APPLICATION NO.	FILING DATE	FIRST NAMED INVENTOR	ATTORNEY DOCKET NO.	CONFIRMATION NO.
10/812,825	03/30/2004	Hiroshi Kurumatani	YAMAP0923US	5087

Office Action Summary

DETAILED ACTION

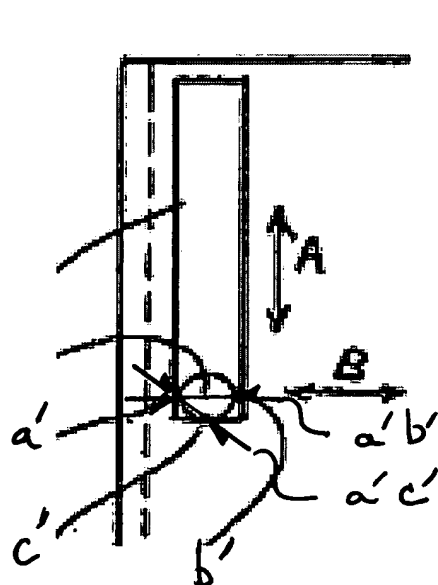
the first guide groove 509 has two ends between which the first projection is movable, the first projection is contactable with at least one of the two ends at two points and the at least one end is formed such that the movement of the first projection toward the at least one end is stopped by the contact with the two points, and the two points have a distance therebetween which is shorter than a width of the first guide groove in a direction perpendicular to the direction in which the sub chassis is movable [see embedded figure; Figs. 12A-B].

the main chassis 400 includes a bottom section, a first side section vertical to the bottom section, and a second side section vertical to the bottom section and facing the first side section [Figure 10];

the sub chassis 500 includes a bottom section, a first side section vertical to the bottom section, and a second section vertical to the bottom section and facing the first side section [Figure 11];

the second guide groove has two ends between which the second projection is movable, the second projection is contactable with at least one of the two ends at two points and the at least one end is formed such that the movement of the second protection toward the at least one end is stopped by the contact with the two points, and the two points have a distance therebetween which is shorter than a width of the second guide groove in a direction perpendicular to the direction in which the sub chassis is movable [see embedded figure; Figs. 13A-B].

• DISTANCE $a'c'$ < DISTANCE $a'b'$.
